Bridge Replacement

On US 30 over Youngs Ditch 0.8 mi. E of SR K-45 Location

SUBJECT: Project Concept Statement; (Final, D0)

Field Exam Notes

PAVED SHOULDER AT GUARDRAIL

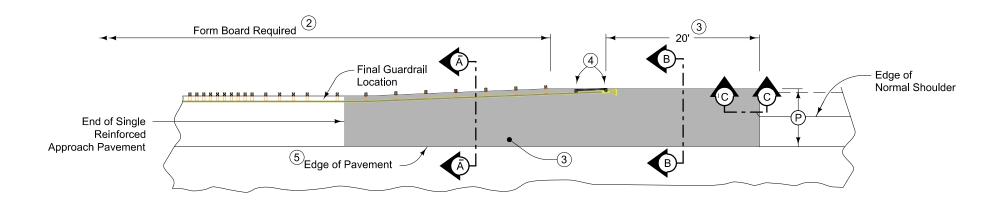
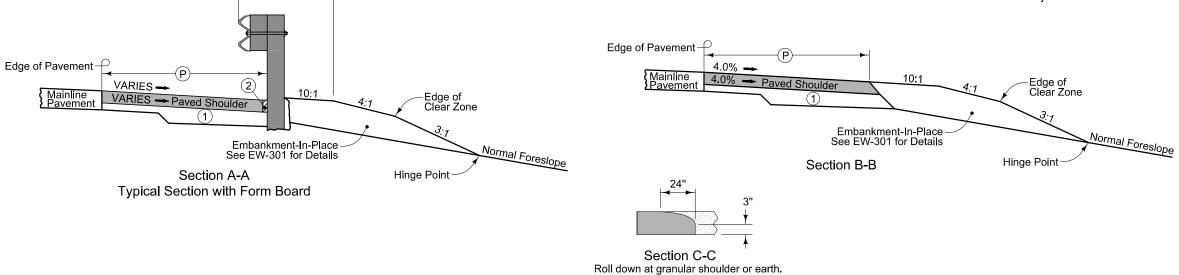
Field Exam Notes

-Full-width (10'), full-depth paved shoulders should extend 300' beyond approach pavement for traffic staging and future maintenance.

Bridge Staging Sheet

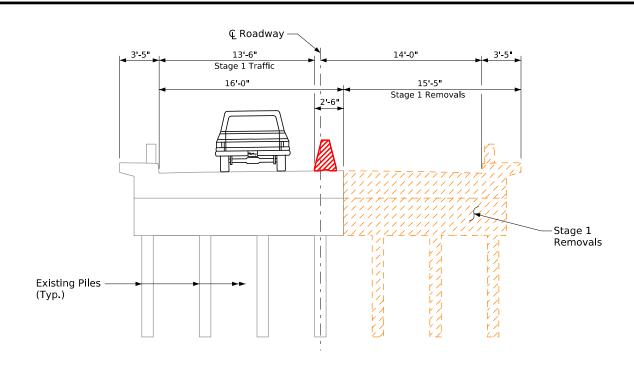
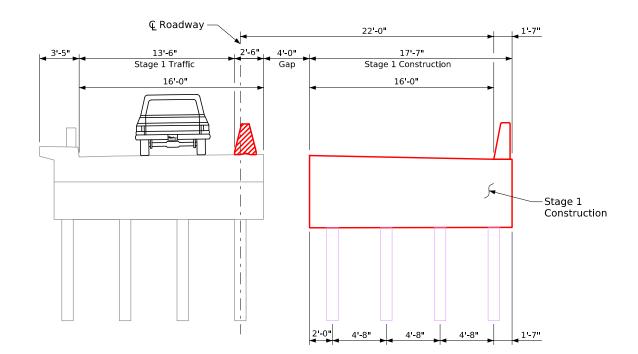
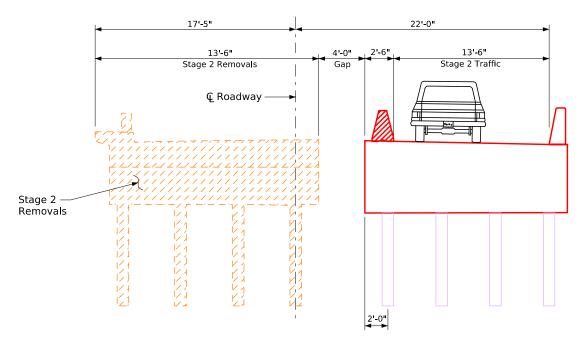
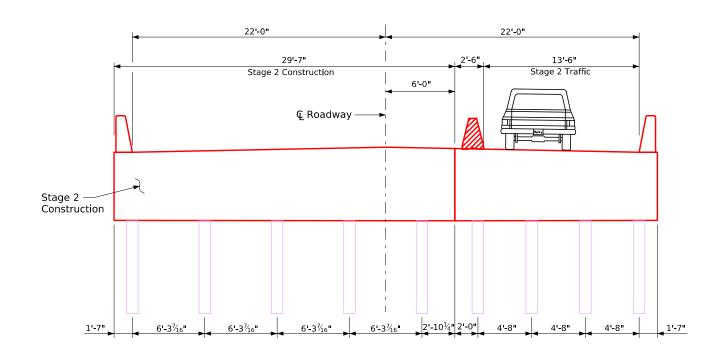
Field Exam Notes

-TBR should be pinned/anchored to the deck due to the limited width available.

-Fully-encased pier piles should be considered during final design.

-Add Designer Note to TSL to make sure forms from Stage 1 remain on for Stage 2 to limit deflection.
